**EXPLANATION OF SIGNIFICANT DIFFERENCES  
OPERABLE UNIT 10 RECORD OF DECISION  
AVTEX FIBERS SUPERFUND SITE**

Site Name: Avtex Fibers Superfund Site

Site Location: Front Royal, Warren County, Virginia

**FIGURE 3A**  
**REVISED PLANT AREA SOILS BOUNDARY**  
**AVTEX SUPERFUND SITE**  
**FRONT ROYAL, VIRGINIA**

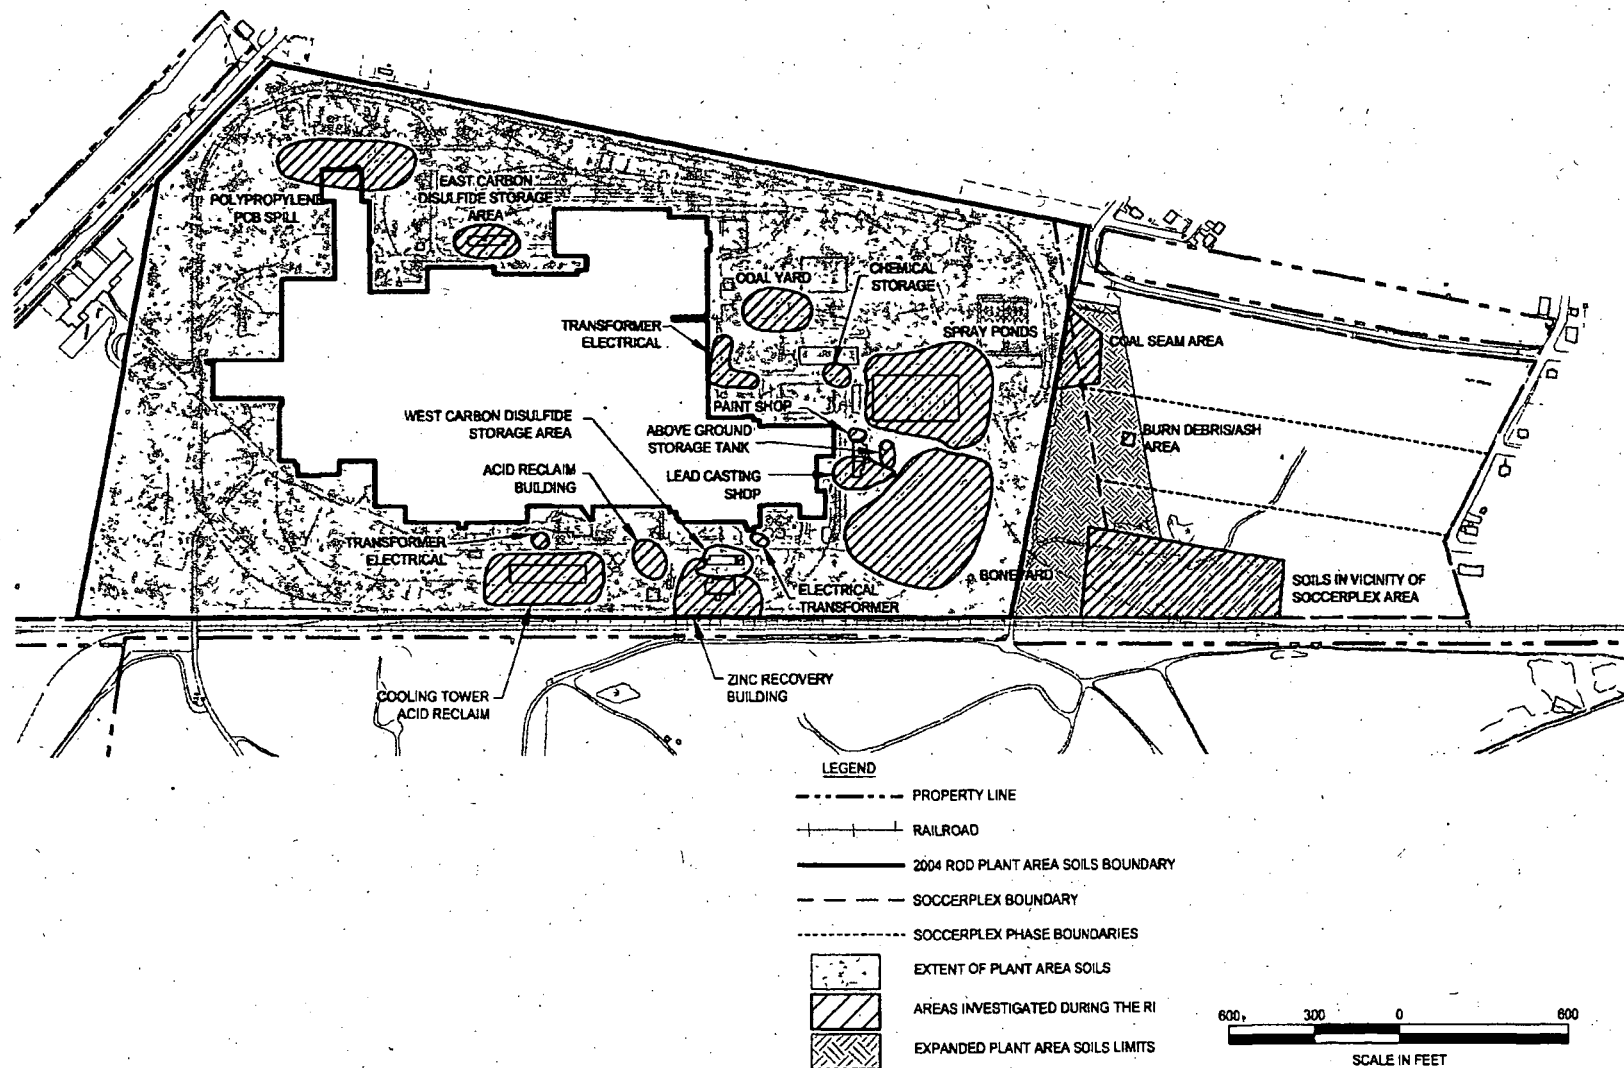
Figure 3A shows the area that shall be referred to as the Expanded Plant Area Soils. The additional areas described above (i.e., Soils in Vicinity of SoccerPlex Area, Burnt Debris/Ash Area, and the Coal Seam Area) are included as part of the Expanded Plant Area Soils.

manufacturing plant. The areal extent of potentially impacted soils was included in the OU-10 ROD as Figure 3. As discussed in Section IV. above, several areas with known contaminated waste and soil and potentially contaminated waste and soil have been discovered outside the area defined as Plant Area Soils. The Expanded Plant Area Soils is now included as part of Plant Area Soils. The modifications to the OU-10 ROD described below address the known and potentially contaminated waste and soil that have been found in the area.

d. Description of Modification for all Soils in the Expanded Plant Area

- i. The soil cleanup standards for OU-10 Expanded Plant Area Soils shall not exceed a cumulative excess cancer risk of  $1 \times 10^{-4}$ . The cumulative effect for non-carcinogens on any target organ shall not exceed a HQ of 1. Table 1A shall be used to identify the soil cleanup standards
